Fosse Green Energy

EN010154

9.8 Applicant's Response to the Examining Authority's First Written Questions

6 February 2026

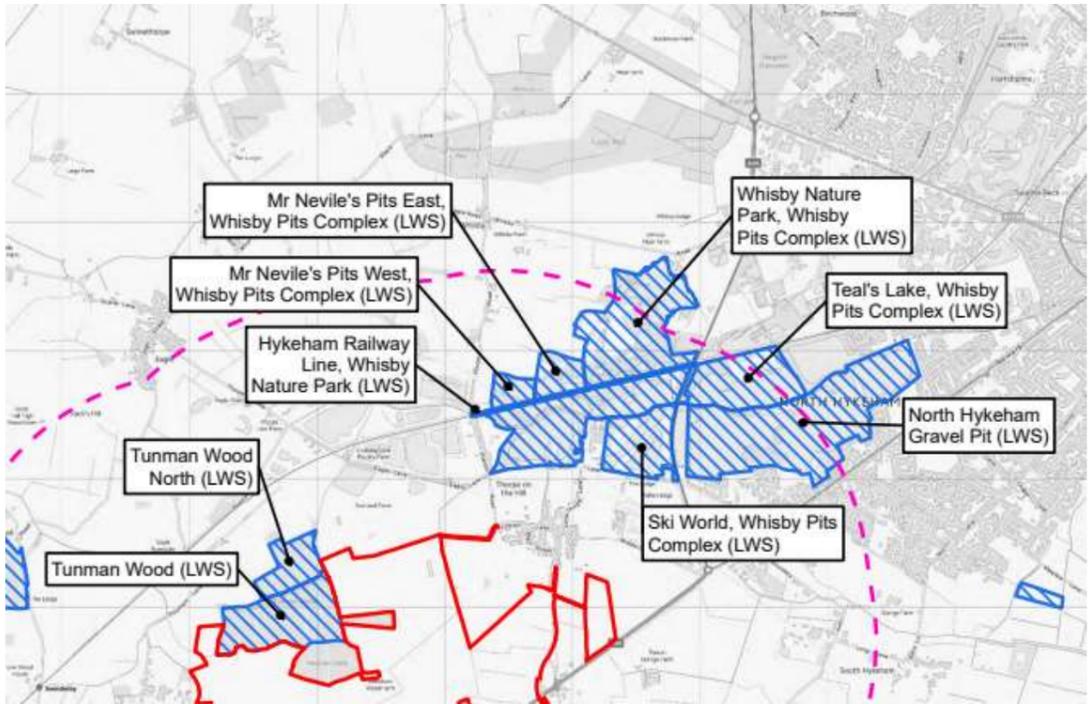
ENC.1.05	Applicant	<p>Baseline – statutorily designated sites</p> <p>Table 8-8 in ES Chapter 8: Ecology and Nature Conservation [APP-033] and Figure 8-1: Sites Statutorily Designated for Biodiversity Value [AS-042] identify Whisby Nature Park as a Local Nature Reserve. In relevant representations [RR-139] and [RR-263] reference is made to Whisby Nature Park as being a Site of Special Scientific Interest.</p> <p>Confirm which is correct and what changes, if any, would be required to the assessment of effects.</p>	The complex of flooded gravel pits northeast of the Order limits is subject to a number of statutory and non-statutory nature designations, some overlapping. As shown on Figure 8-1: Sites Statutorily Designated for Biodiversity Value [AS-042] (see image below for reference) an area is designated as the Whisby Nature Park Local Nature Reserve (LNR). The Swanholme Lake Site of Special Scientific Interest (SSSI), located further to the northeast, has potentially been confused with the Whisby Nature Park LNR in Relevant Representations [RR-139] and [RR-263].

In addition to the above statutory designations, and as shown on Figure 8-2: Sites Non-statutorily Designated for Biodiversity Value of the ES [AS-043] (see image below for reference), a number of the flooded gravel pits are also designated as Local Wildlife Sites (LWS), including those also designated as the Whisby Nature Park LNR.
